STAFF RECOMMENDATION
1406 Fifth Avenue North
November 19, 2018

Application: Partial Demolition; New construction—Additions
District: Germantown Historic Preservation Zoning Overlay
Council District: 19
Map and Parcel Number: 08209008800
Applicant: John Root, Architect
Project Lead: Melissa Baldock, melissa.baldock@nashville.gov

Description of Project: Application is to demolish non-contributing portions of the house, and to construct a front porch and rear additions. The rear addition is proposed to be eight feet, four inches (8'4") taller than the historic house. The Commission approved the proposed partial demolition and the new additions in decisions from 2015 and 2016, but these preservation permits have since expired. In addition, the design guidelines have changed since that decision.

Figure 5 (right) is the 1897 map; Figure 6 (middle) is the addition to be demolished on the left side; and Figure 7 (right) is the addition to be demolished on the left side.

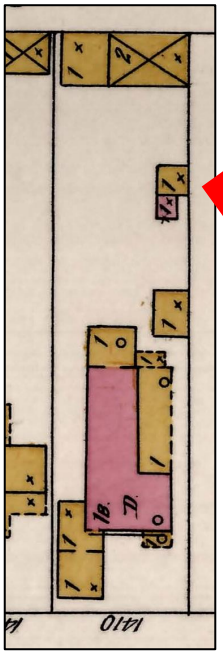
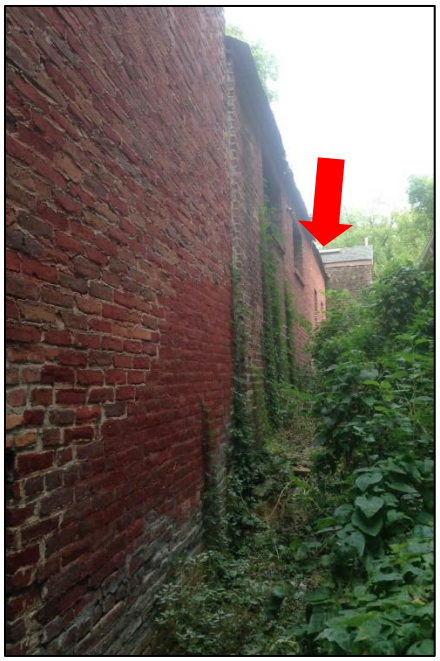
Partial Demolition. The applicant proposes to demolish an existing addition at the rear of the house. This part of the structure does appear on an1897 map, and is shown as a frame element form distinct from masonry portion of the house (Figure 5). The existing addition is clad in siding and has a separate roof form from the brick house (Figures 6 - 8), as well. It is located more than forty-feet (40') from the front of the house on the right side and about fifty feet (50') from the front on the left side. It is at most minimally visible from the street. Staff finds that the existing addition does not contribute to the historic character of the historic house at 1406 Fifth Avenue North and to the Germantown Historic Zoning Overlay as a whole. Staff finds that its demolition meets Section VII.B.2. for appropriate demolition and does not meet Section VII.B.1. for inappropriate demolition.

Figure 6 is a view of the existing addition from the rear yard.

Figure 4: 1406 Fifth Avenue North, c. 1970

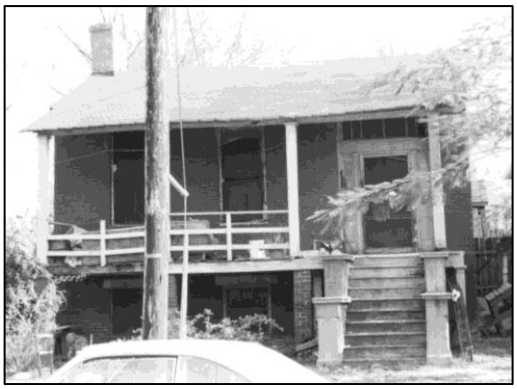
Front Porch Addition: The applicant proposes to construct a full-width front porch, with a footprint matching that of the porch shown on the 1914 Sanborn map. Although the house did not originally have a full-width porch, it did have one added that remained long enough to have historical significance of its own (See figures 2,3,4). For this reason, staff finds that reconstruction of a full-width porch to be appropriate.

The roof of the porch will be hipped, tying into the front of the house at the bottom of the front eave line. The porch floor height will match that of the existing front porch. The porch will have five square columns along the front edge. The roof form and column configuration are similar to the porch depicted on the c. 1970 photo. Staff finds that because the porch depicted in the c. 1970 photograph may not be the exactly the original design, staff found that a similar configuration is appropriate. The differences are minimal including hipped roof rather than shed and slightly different pier configuration but still with an open basement level. The porch will have a depth of five feet (5'). Typically, the design guidelines call for porches to be a minimum of six feet (6') deep. However, in this case, the previous full width porch was just five feet (5') deep, so a new five foot (5') deep porch is appropriate. Staff finds that the proposed new front porch meets Section V.B. of the design guidelines

Figure 7 shows the contour elevations for the lot.

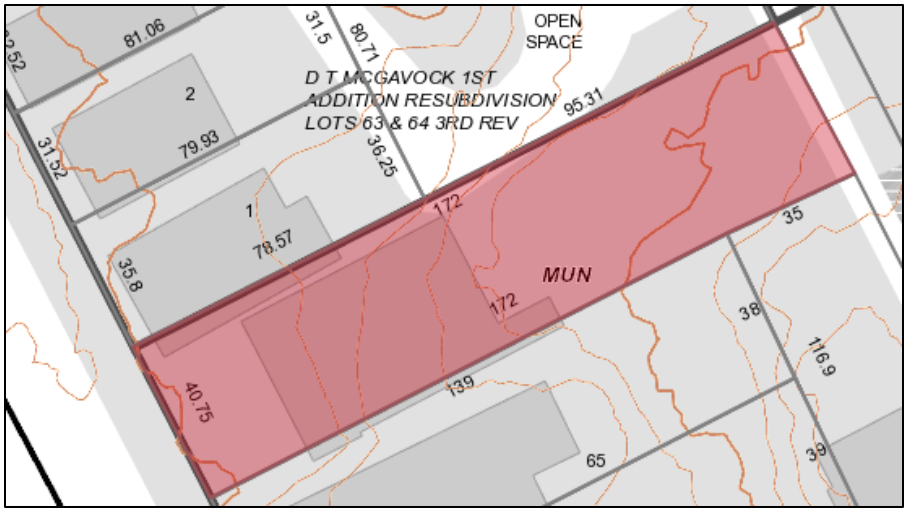
Examining the proposed addition under the current Germantown design guidelines, staff finds that its insets, width, depth, and footprint meet the design guidelines. The height of the addition, however, does not meet the current design guidelines. The previous Germantown design guidelines did not discuss situations when additions could go taller than the historic house; they did not provide a maximum additional height or parameters for when taller additions would be appropriate. Many of the other MHZC design guidelines for residential neighborhood conservation and historic preservation zoning overlays state, in italicized print, that an addition may extend up to four feet (4') taller than the historic house at a distance forty feet (40') back from the front of the house. In the 2015 staff recommendation, staff recommended that because the addition was more than fifty feet (50') back from the front of the house, the addition should be limited to being five feet (5') taller than the historic house. However, the Commission approved the addition to be eight feet, four inches (8'4") taller because of the slope of the lot.

The current design guidelines now state, in italicized print, that "*when a taller addition is the only option,*" additions can be up to four feet (4') taller than the historic house at a point forty feet (40') back from the front of the house. Staff finds that an addition that is taller than the historic house could be appropriate for this lot because of the slope of the site. The site is steeply sloped upwards towards the back of the lot; there is a difference of about ten feet (10') from the front of the lot to the rear (Figure 7). The lot's ground is rock, making it difficult and expensive to dig and level the slope. However, staff is not supportive of the proposed height of the addition which is a two-story addition on a one-story house. Since the current design guidelines specifically limit the height of additions to be no more than four feet (4') taller than the historic house, staff recommends that the addition be reduced in height by four feet, four inches (4'4") in order to meet the current design guidelines. Staff finds that the proposed rear addition's height is out of scale with this one-story with a raised basement house, and that reducing the addition's height to be no taller than four feet (4') taller than the historic house would make the addition more compatible with the historic house.

With the condition that the addition be reduced in height to be no taller than four feet (4') taller than the historic house, staff finds that the proposed addition meets Section V.2. of the design guidelines.

Figure 8. The 1897 Sanborn map shows the brick portions as pink and the frame construction as yellow. The rear and right/south facades were not 80% brick.

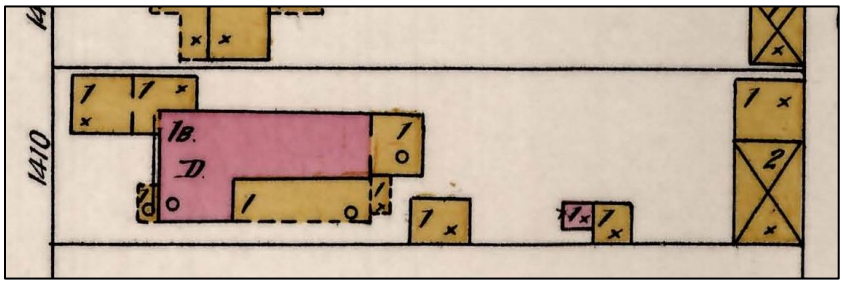
*The design guidelines state that "All facades shall be at least 80% brick. A greater percentage of accent materials may be used on facades that are not visible from a public right-of-way." The applicant is proposing an addition that is entirely clad in siding, making the left/north façade fifty-two percent (52%) brick and the right/south façade forty-seven percent (47%) brick. The rear façade is almost entirely siding, with only the two feet (2') of brick walls at the back of the historic house being brick. Staff finds that in this case, having an addition that contains no brick is appropriate because historically, the historic house had substantial amounts of non-brick facades. Both the 1897 and the 1957 Sanborn maps show that the entire back of the house was frame and not brick and that about two thirds of the right/south façade was an enclosed wood porch (Figures 8 & 9). Parts of that wood porch section are now brick. Since historically, appendages and additions to this historic house were frame and not brick, staff finds that the proposed lap siding material to be appropriate for the addition. Staff finds that the percentage of brick on the side and rear façade to be in keeping with the historic character of 1406 5th Avenue North.

Staff recommends approval of a brick sample and the color and texture of the roof shingles. With staff's final approval of all material choices, staff finds that the known materials meet Sections III.E.5. and V. of the design guidelines.
